Re: Supplemental Comments on Draft Environmental Impact Report for Saranap Village Mixed Use Project (SCH # 2014032060)

Subject: Comments on the Saranap Village Mixed-Used Project, Contra Costa County

¹² *Ibid.*, p. 5-9 (Figure 5-3).

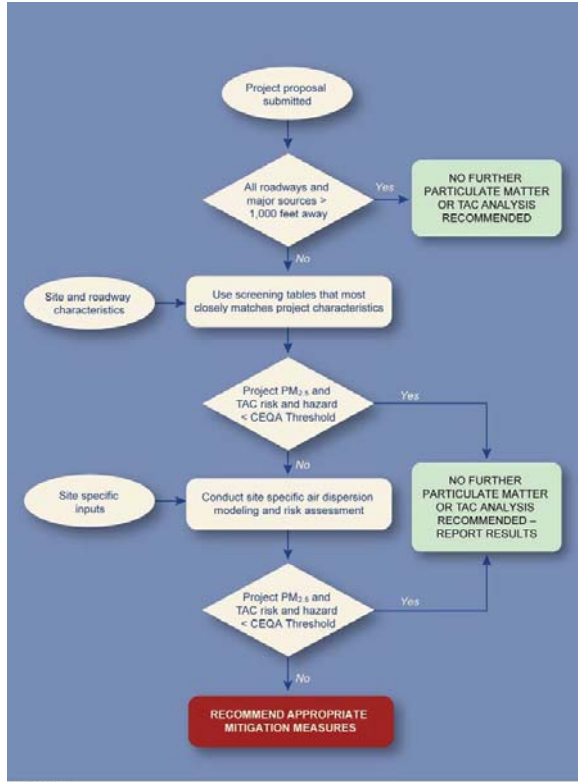
The BAAQMD Guidelines provide a diagram to illustrate this process:¹²

The air quality data attached to DEIR Appendix B includes an interpolated estimate of lifetime cancer risk to Project receptors of 13 in 1 million from Highway 24, based on the highway screening analysis tool, assuming a receptor height of 6 feet and a distance 735 feet from the edge of westbound Highway 24.¹⁴ According to Mr. Hagemann and Mr. Jaeger, this is likely an underestimation of the risk to on-site receptors.¹⁵ The highway screening analysis tool is intended to represent the entirety of Highway 24, not just its westbound lanes, which are farther from the Project site. The edge of the highway's "nearest travel lane to the project" is less

than 600 feet, not 735 feet as assumed in the Project data. Accordingly, the risk is likely greater than 13 in 1 million, which is well above the threshold of significance for cancer risks from a single source of 10 in 1 million.

Accordingly, “a more refined modeling analysis is recommended or the lead agency may choose to implement mitigation measures.”¹⁶ The DEIR fails to disclose this significant impact, and also fails to conduct a more refined modeling analysis or impose mitigation measures. Moreover, as explained by Mr. Hagemann and Mr. Jaeger, the DEIR fails to analyze the effects of on-site sources of TACs and fine particulate matter on Project residents.¹⁷ The DEIR must be revised and recirculated to disclose and mitigate these potentially significant effects.
